[EERE-2021-BT-TP-0019]

**Energy Conservation Program: Test Procedure for VRF Multi-Split Systems**

**ACTION:** Final rule.

**Figure III-1: DOE's Proposed Enforcement Process from the December 2021 VRF TP NOPR**

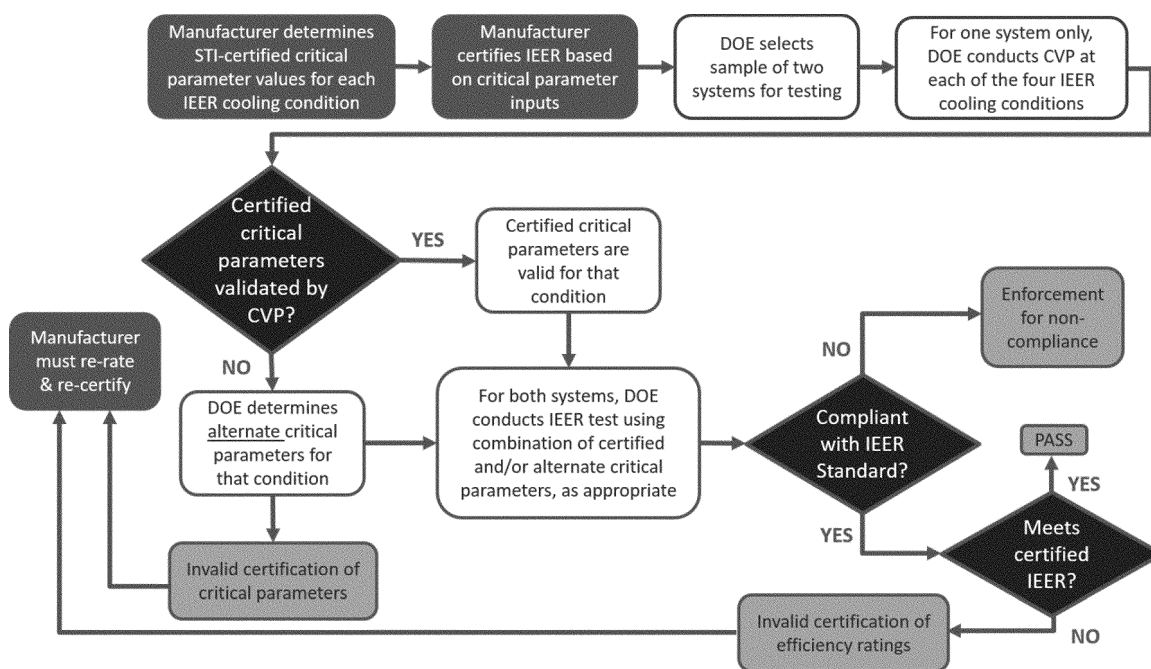
Daikin commented that this figure illustrates that regardless of whether a CVP is performed, the basic model must be re-rated if the IEER testing results are deemed invalid. Daikin asserted that the proposed regulatory text did not indicate that if critical parameters are validated but the IEER is not validated then a re-rate is required, as indicated in the figure. (Daikin, No. 13 at p. 7)
